SITE PLAN REVIEW AND APPEARANCE BOARD

Delray Ridge

Meeting	File No.	Application Type
June 22, 2022	2022-109	Class II Site Plan Modification

Consideration of a Class II Site Plan Modification, Landscape Plan, and Waiver for Delray Ridge associated with the development of 14 single-family homes and site improvements.

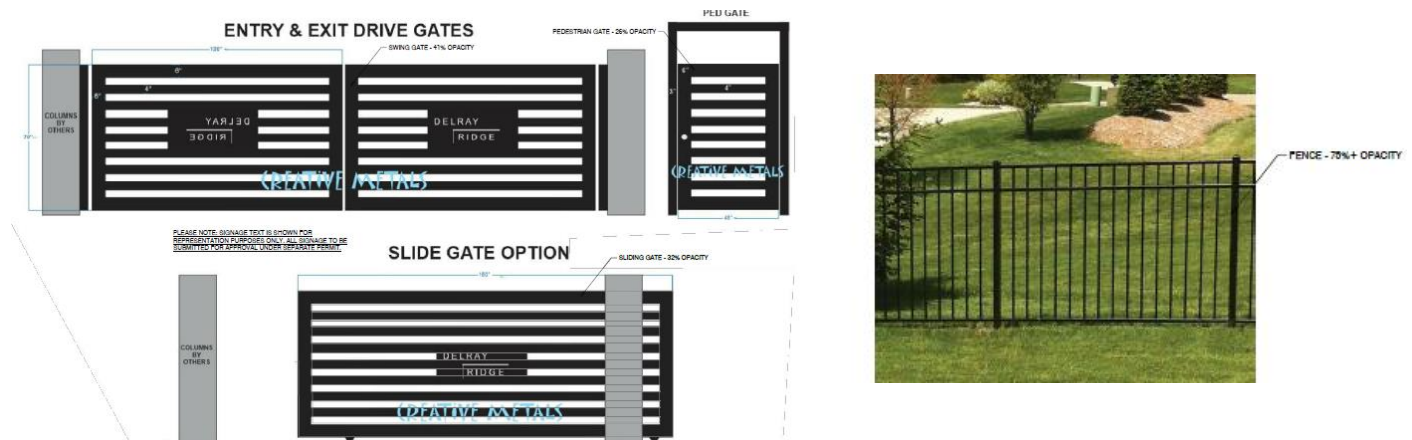
A 6-foot-high precast site wall, painted with white color, is proposed along the perimeters of the development. For the areas subject to site visibility clearance, the fence with 75 % opacity is incorporated to the site wall design. Decorative horizontal gates are proposed for the main entrance along N. Swinton Ave and the egress along NE 22 Street.

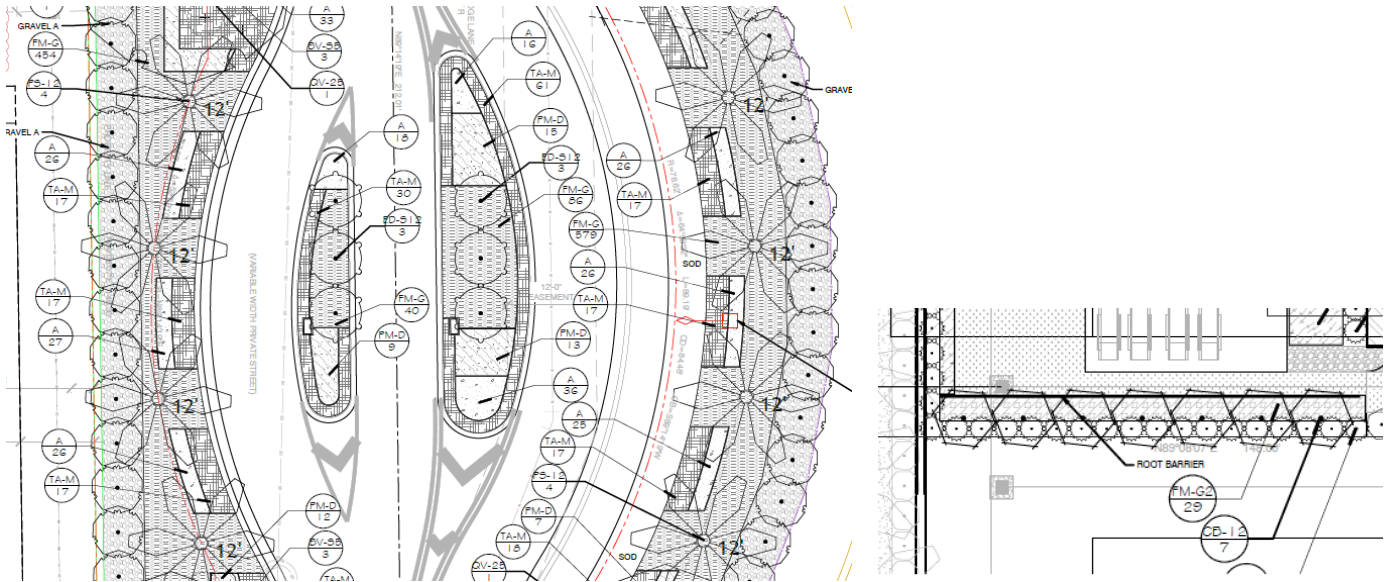
2. The applicant proposes Brazilian Beautyleaf trees (CB: Calophyllum Brasiliense) to create the visual barriers along the main entrance and interior perimeters for individual lots. The space arranged for those trees is less than 10 ft interval, which may stress an overall growth of such trees as defined in LDR Sec. 4.6.16 (E)(5), quoted below. The project landscape architect is confident that the space given for these trees would not be concerned for the growth but provide a visual barrier and enhance the appearance of the development.

Pursuant to LDR Section 4.6.16 (E)(5), Trees shall be a species having an average mature spread of crown greater than 20 feet and having trunks which can be maintained in a clean condition with over six feet of clear mature wood. Trees having an average mature spread of crown less than 20 feet may be substituted by grouping the same so as to create the equivalent of a 20-foot spread of crown. Tree species shall be a minimum of 16 feet in overall height at the time of planting, with a minimum of six feet of single straight trunk with eight feet of clear trunk, and a seven-foot spread of canopy. Tree species required for single family homes and duplexes shall be a minimum of 12 feet in overall height at the time of planting, with a minimum of four feet of single straight trunk with six feet of clear trunk, and a six-foot spread of canopy.
